**TOWN OF KENT PLANNING BOARD  
October 14, 2021  
FINAL MINUTES**

• **Maniatis Property, 250 East Boyd's Lake Road, Kent, NY: TM: 31.-2-51**

Subject: Erosion Control Plan – Revised  
Submittal

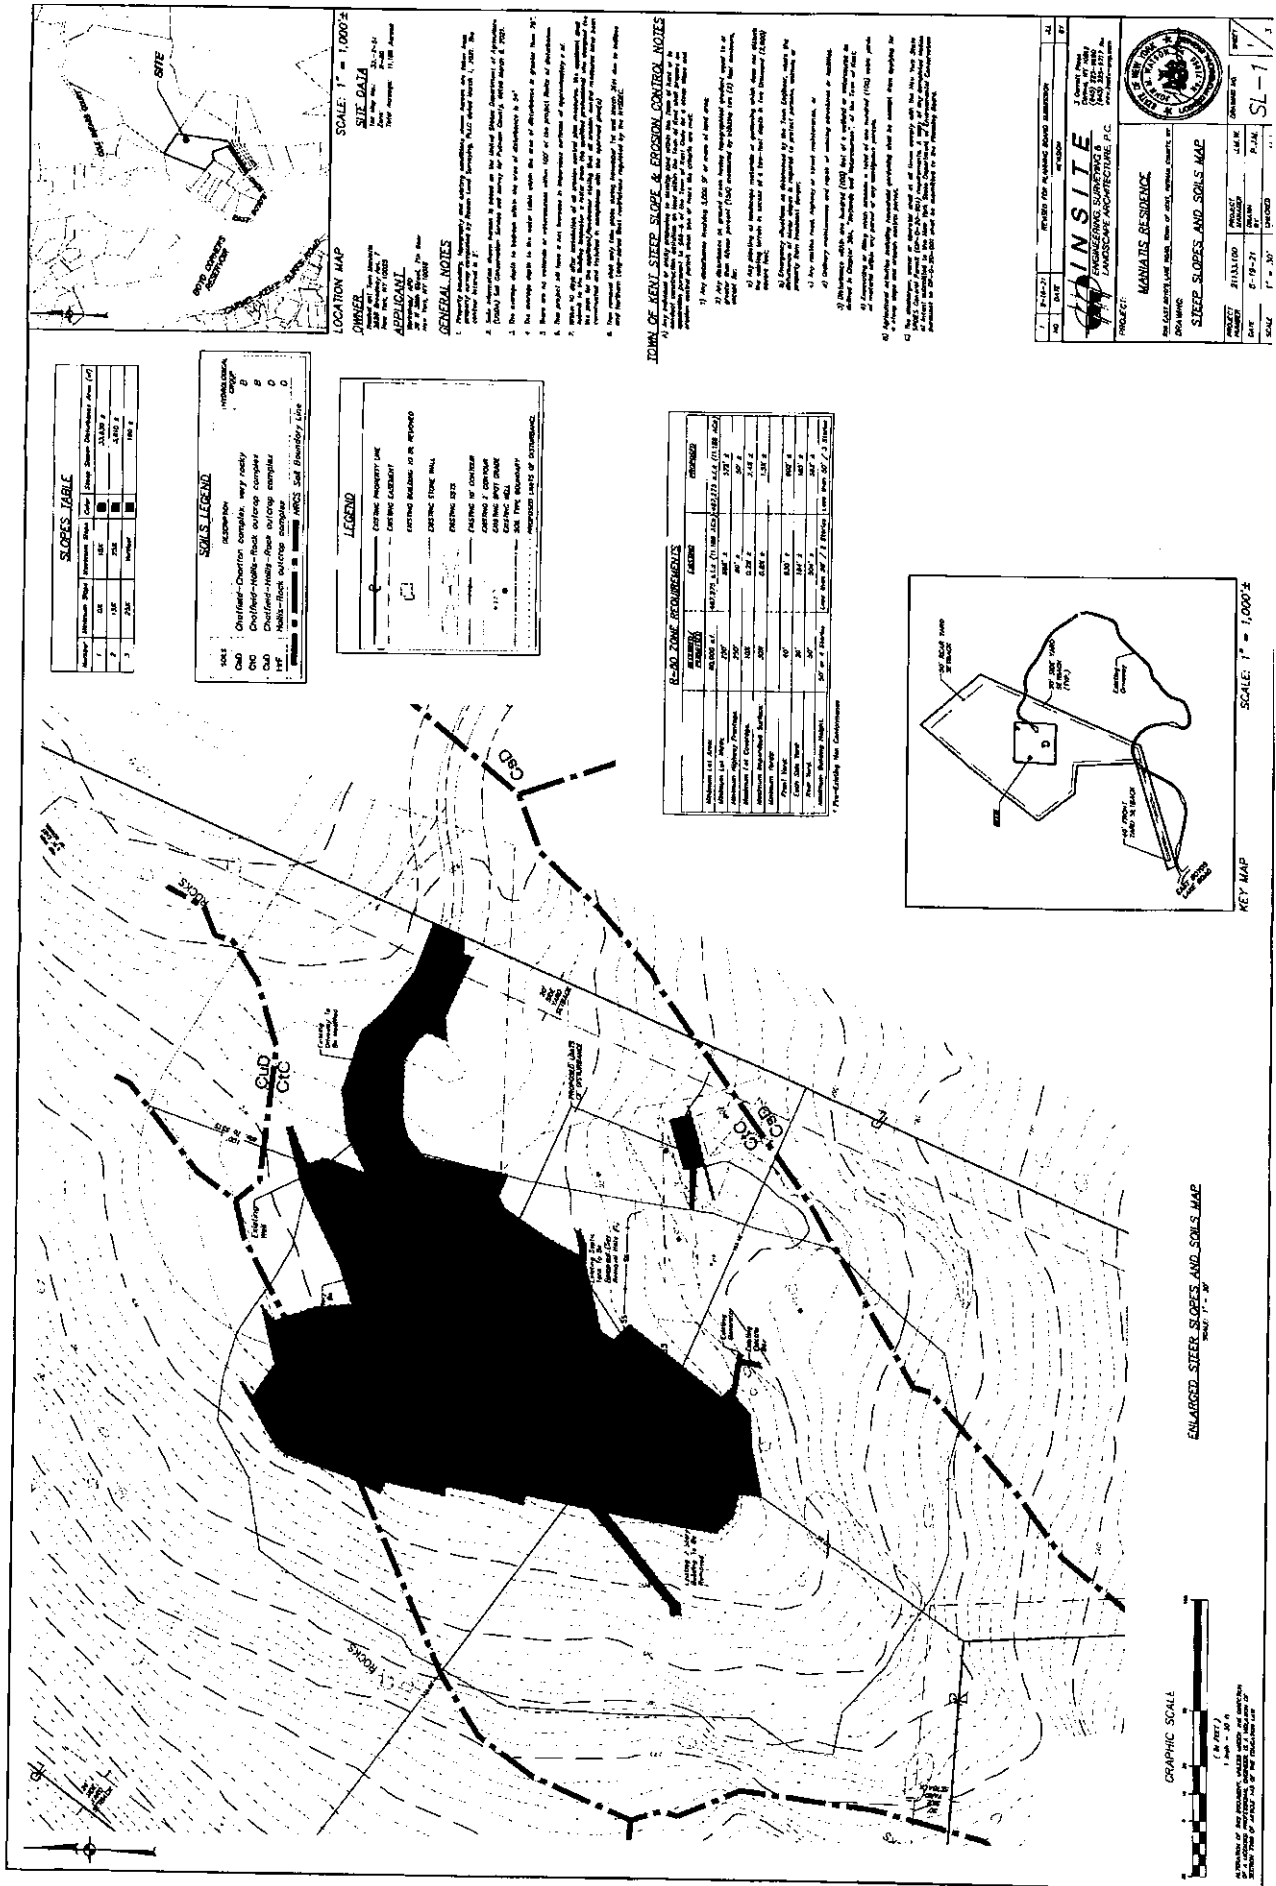
5. Refer to the Drawings:
  - a. General Note No. 6 indicates a decrease in impervious surfaces. The Zoning Table reflects an increase in impervious surface. Future submittals shall correct the inconsistency. **General Note No. 6, Dwg SL-1 has been revised to reflect an increase. The increase in impervious surface is left blank and should be filled in**

- b. The electric service and existing generator are located outside the proposed limits of disturbance. Improvements to the electric service should be noted on the plan set. Details of the connection of this service to the new structure should

also be shown with any modifications to the limits of disturbance noted.

**Resolved**
